UNITED STATES PATENT AND TRADEMARK OFFICE

APPLICATION NO.	FILING DATE	FIRST NAMED INVENTOR	ATTORNEY DOCKET NO.	CONFIRMATION NO.
10/578,351	05/05/2006	Nobuo Aoi	071971-0549	6820

Office Action Summary	Application No. 10/578,351	Applicant(s) AOI ET AL.	
	Examiner Jasmine J. Clark	Art Unit 2815

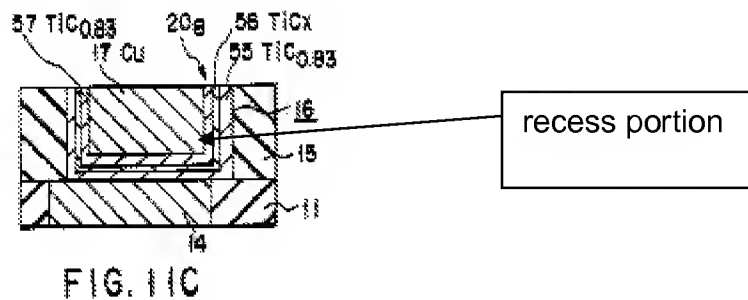
Kawanoue '211 discloses a semiconductor device comprising: an insulation film (11 and 16) formed on a substrate; a buried wire (14) formed in the insulation film; and a barrier metal film formed between the insulation film and the buried wire, wherein the barrier metal film contains oxygen as a component element, and wherein a concentration of oxygen (inherent) contained in the barrier metal film continuously varies in a film thickness direction of the barrier metal film.

Kawanoue '211 further discloses a method for fabricating a semiconductor device, the method comprising the steps of:

forming a recess portion in an insulation film (see Fig. 11C above, i.e.,) provided on a substrate;

forming a barrier metal film containing oxygen as a component element so that the barrier metal film covers surfaces of the recess portion; and forming a buried wire (17) on the barrier metal film so that the recess portion is filled, wherein the step of forming the barrier metal film includes the step of forming the barrier metal such that a concentration of oxygen contained in the barrier metal film continuously varies in a film thickness direction of the barrier metal film is inherent.
